Access Compliance Report

Public Rights-of-Way

(Curb Ramps)

Intersection ID: 11799	Main Street: MECKLENBURG_AV	Cross Street: NORCROSS_PL	Location: SW
ADA ID: 22C6E9608D2D	Ramp Type: Directional1	Initial Pass/Fail: Fail	Overall Compliance: No
			Severity Score: 13.75

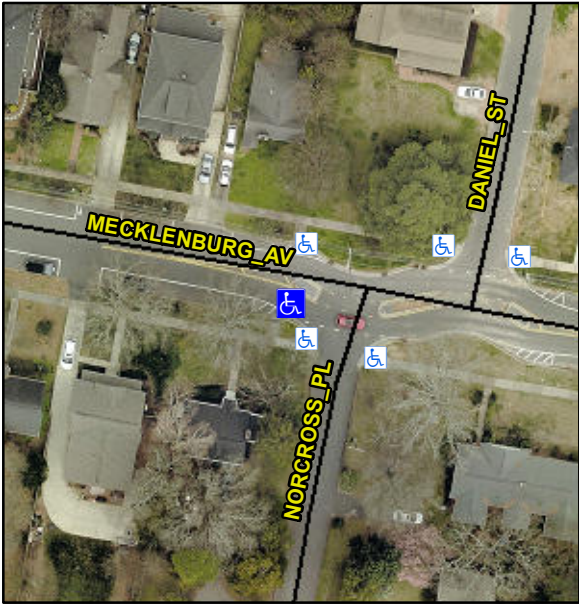
Codes/Mitigation Info/Possible Solution			Field Measurements/Component Compliance					
 <div>Street 1 Name<div>MECKLENBURG AV</div></div> <div>Stop Condition-Street 1<div>None</div></div> <div>Street 2 Name<div>N/A</div></div> <div>Stop Condition-Street 2<div>N/A</div></div>	Possible Solutions:		Compliance			Compliance		
	Remove & Replace Entire Ramp.		N/A	Ramp Length (in)	109.0	N/A	Grade Break?	N/A
			Yes	Ramp Width (in)	59.0	N/A	Grade Break Slope (%)	0.0
			No	Ramp Slope (%)	8.7	N/A	Grade Break XSlope (%)	0.0
			No	Ramp XSlope (%)	3.4			
			N/A	Flare Type LT	N/A	N/A	Flare Type RT	N/A
			N/A	Flare Slope LT (%)	N/A	N/A	Flare Slope RT (%)	0.0
			N/A	Flare Traversable LT?	N/A	N/A	Flare Traversable RT?	N/A
	Surveyor Notes:		N/A	Landing Length (in)	0.0	N/A	DWS Provided?	N/A
				N/A	Landing Width (in)	0.0	N/A	DWS Contrast?
			N/A	Landing Slope (%)	0.0	N/A	DWS Length (in)	N/A
			N/A	Landing X Slope (%)	0.0	N/A	DWS Full Width?	N/A

PROW/ADA:			N/A	Landing Curb? (Y/N)	N/A	N/A	DWS Offset LT (in)	N/A
R304.2.2, R304.5.3			N/A	Shared Landing?	N/A	N/A	DWS Offset RT (in)	N/A
			N/A	Gutter Ponding?	0.0	N/A	Gutter Slope (%)	N/A
			N/A	Gutter Lip Ht (in)	0.0	N/A	Gutter X Slope (%)	N/A
			N/A	Painted X Walk1?	No		Road Slope (%)	3.6
				X Walk 1 Direction	To N		Road X Slope (%)	3.0
				X Walk 1 Width (in)	N/A		Clear Space?	N/A
				X Walk 1 Slope (%)	3.6	N/A	Clear Space to XWalk (in)	N/A
				X Walk 1 X Slope (%)	3.0	N/A	Storm Grate/Utility Hazard?	N/A
			N/A	Ramp inside XWalk1?	N/A		Storm Grate/Utility Type	
			N/A	Any Obstructions?	N/A			N/A
				Obstruction Type		Yes	Surface Condition? (G/P)	Good
						N/A	Curb Slope (%)	7.6
Total Cost:		\$ 1600.00
